## Appeal 34829

**Status:** Decision Rendered - Reconsideration of 34808

**Project Address:** 3440 SW Falcon St., Portland OR 97219

**LUR or Permit Application #:** Permit 25-027199 and 25-040811

### Alternate Stair Firewall Support

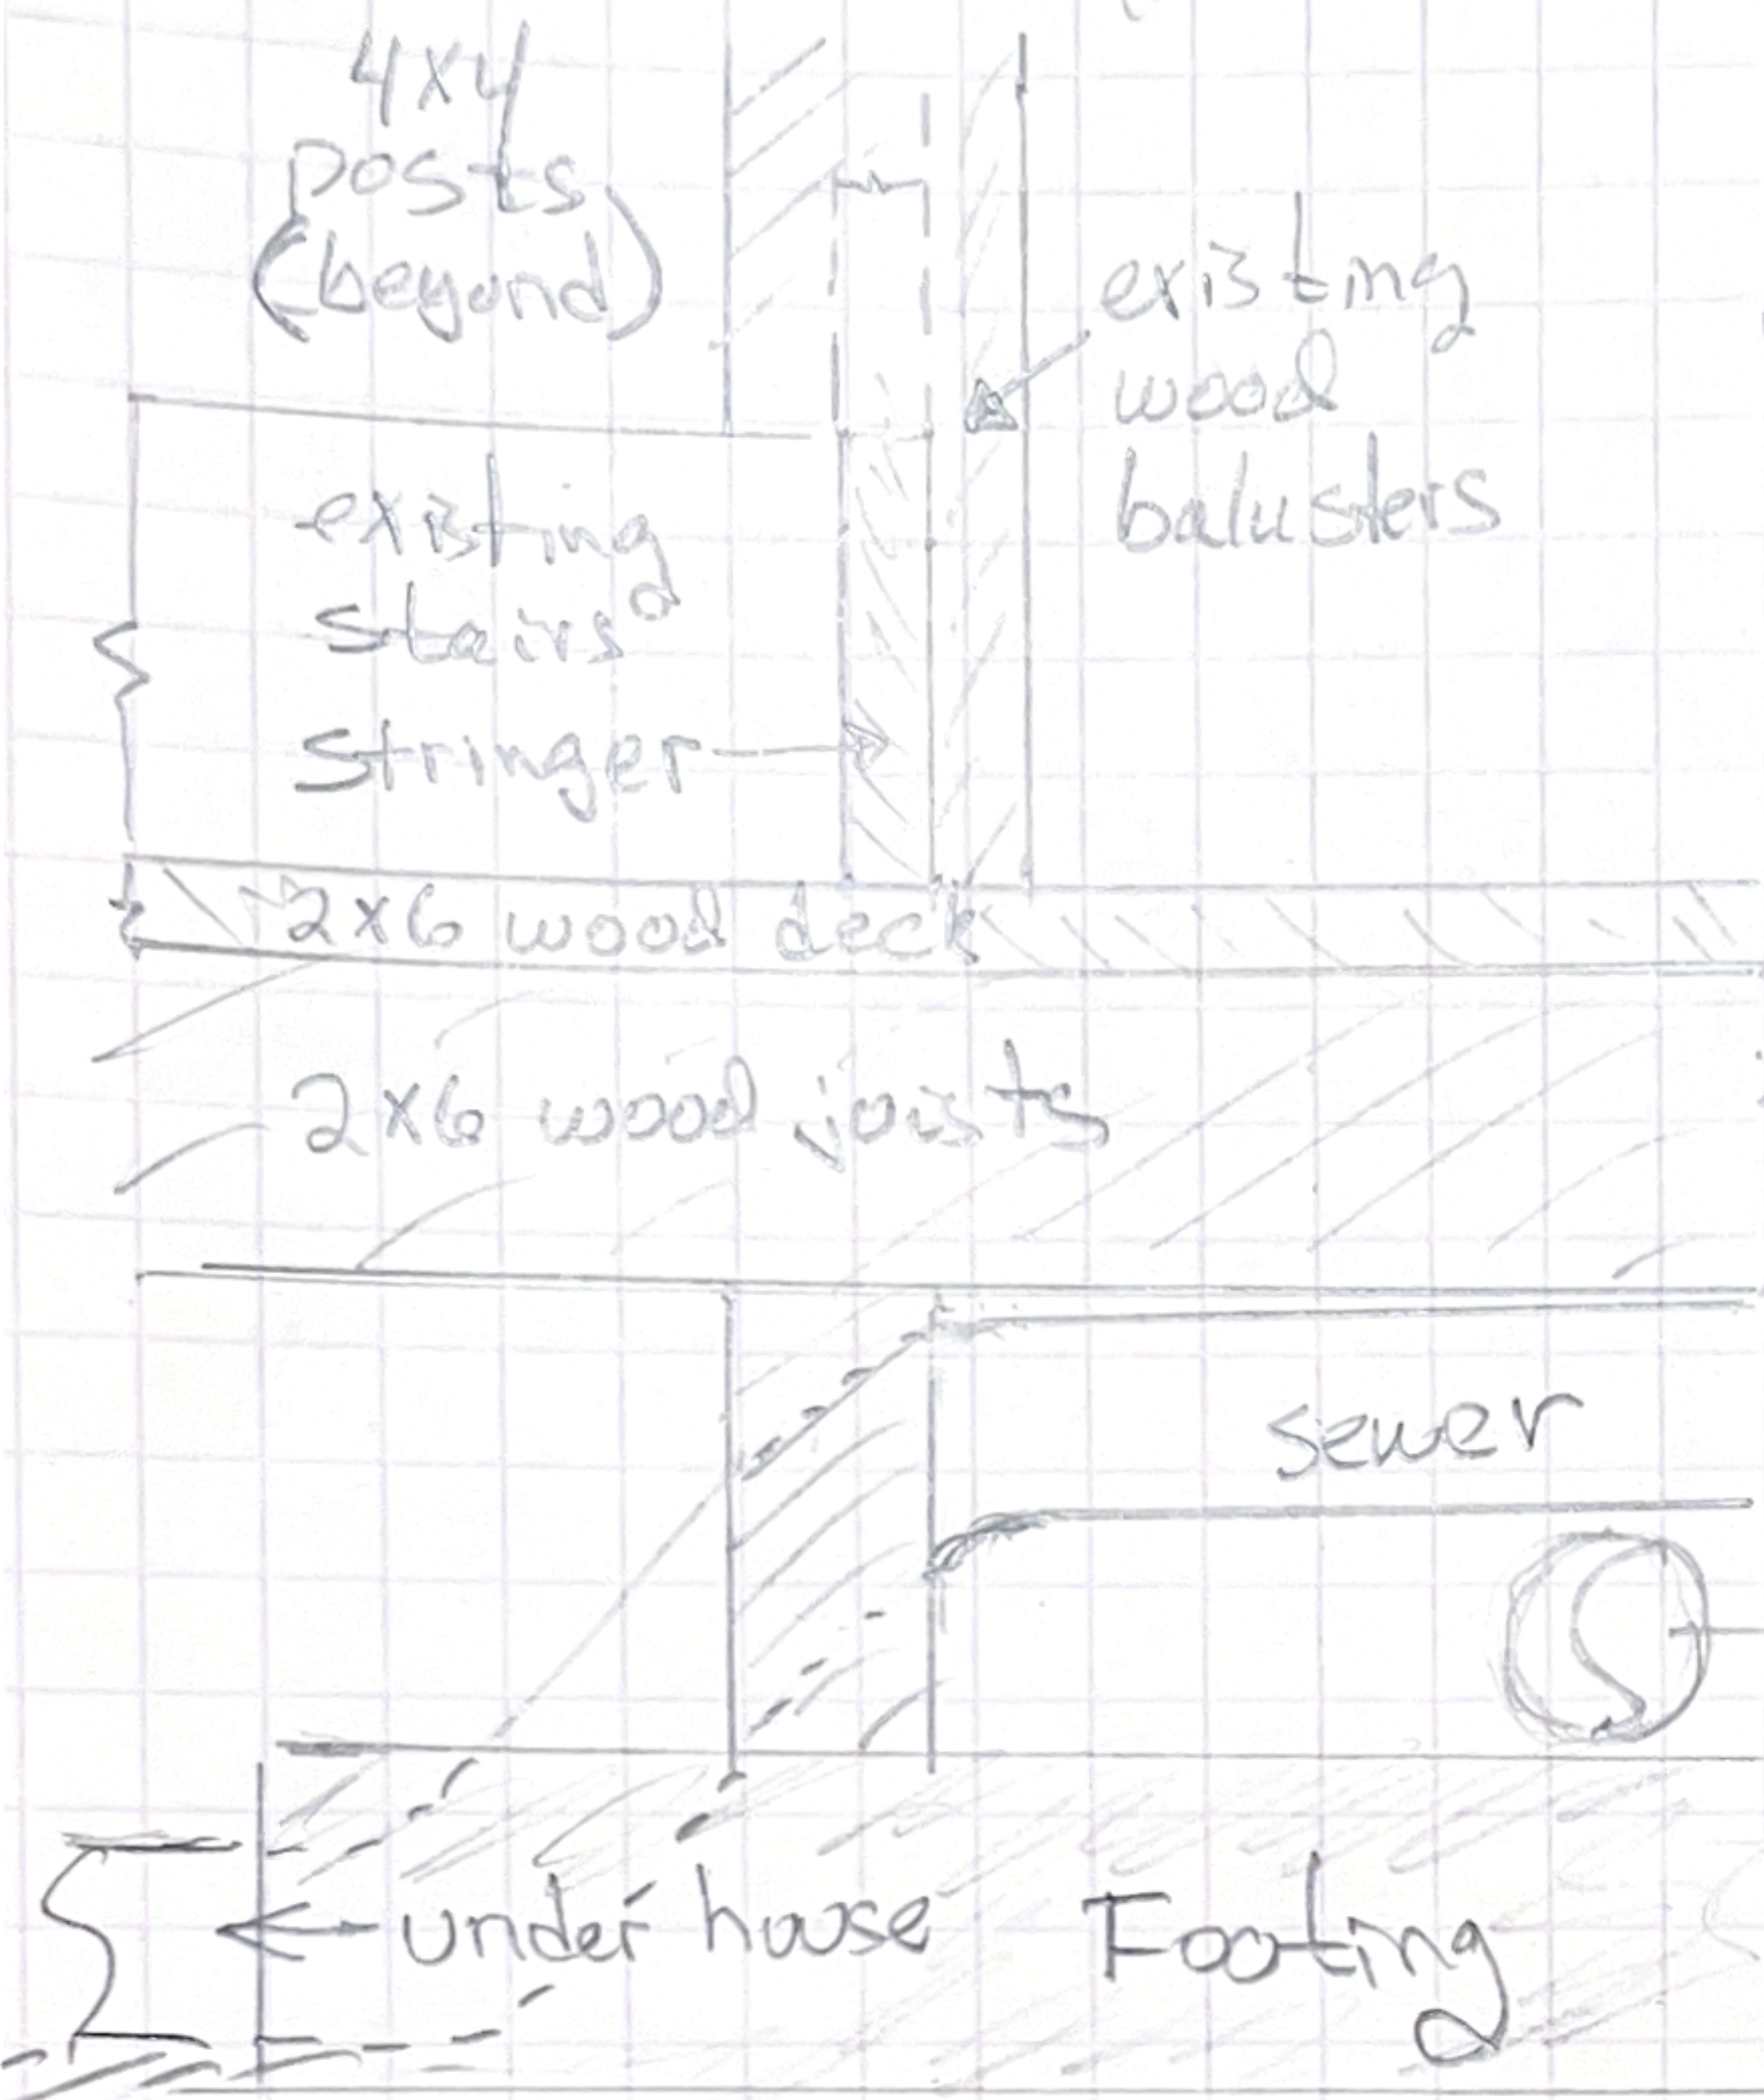
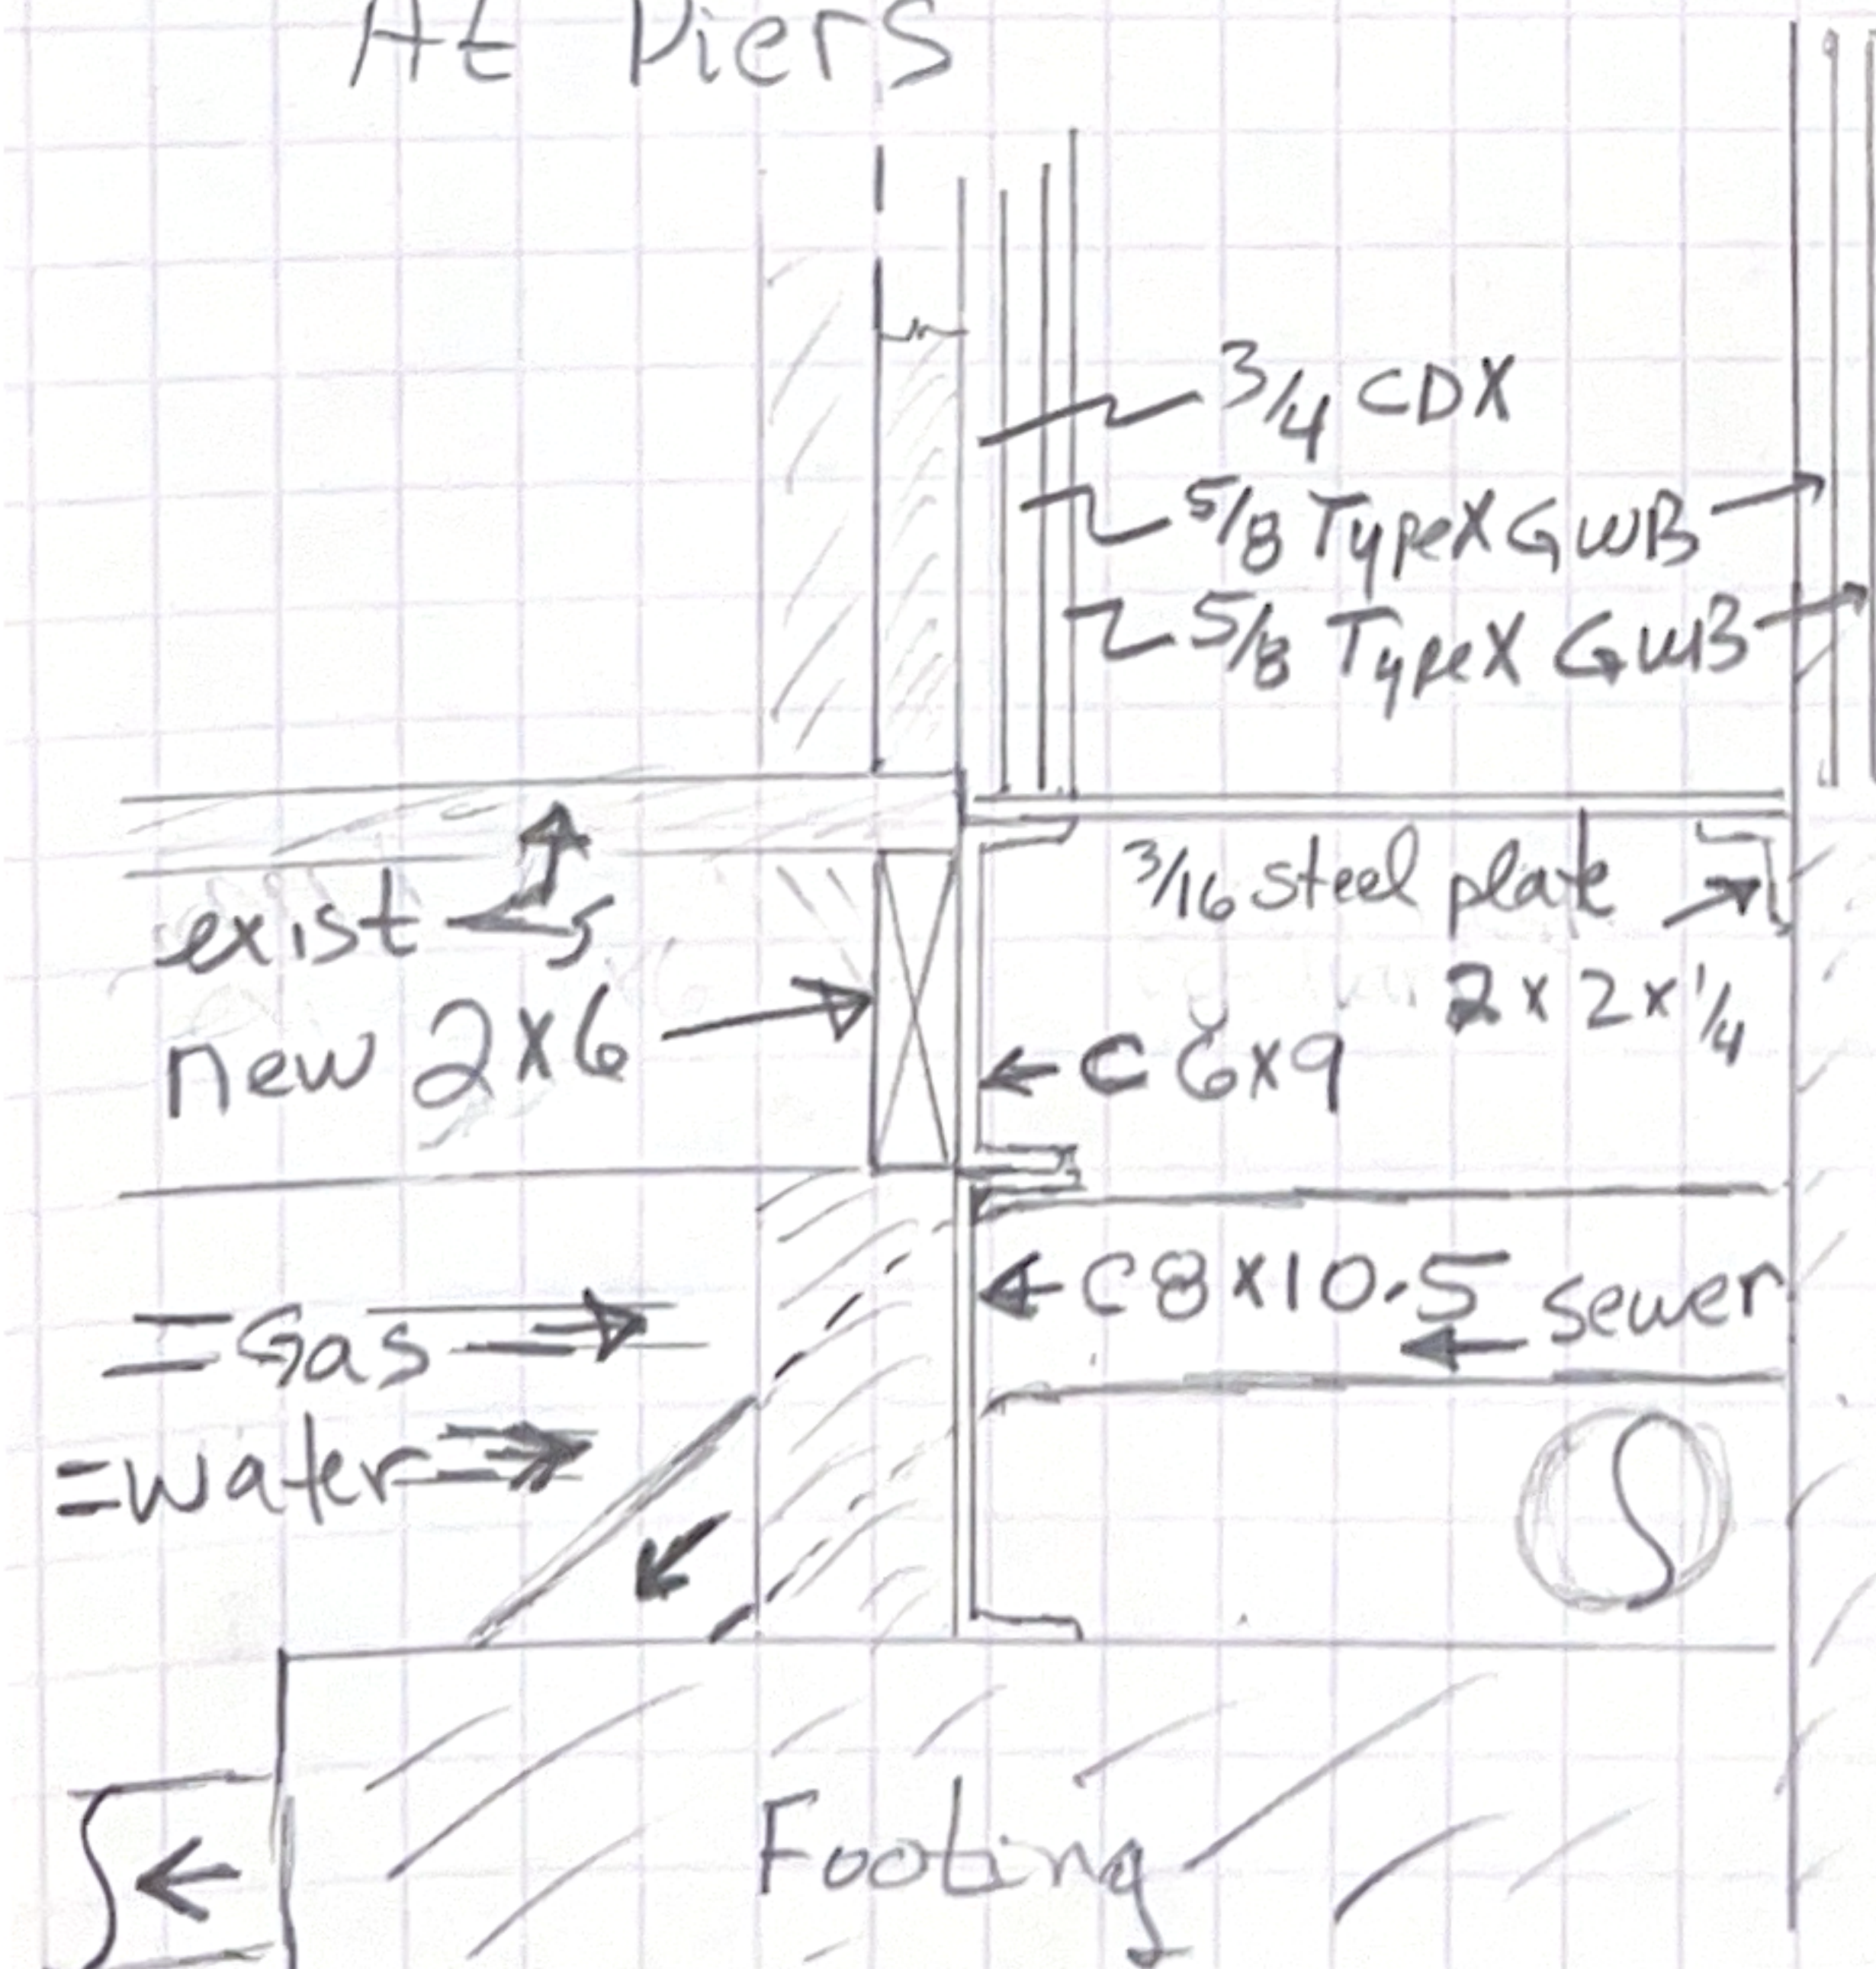
**"Allow an alternate path to meeting the requirement for 1-hour fire-resistance rated construction at an egress stairway: Denied. Proposal does not provide equivalent fire and life safety. Appellant may contact David Bartley (503-865-6529) with questions."**
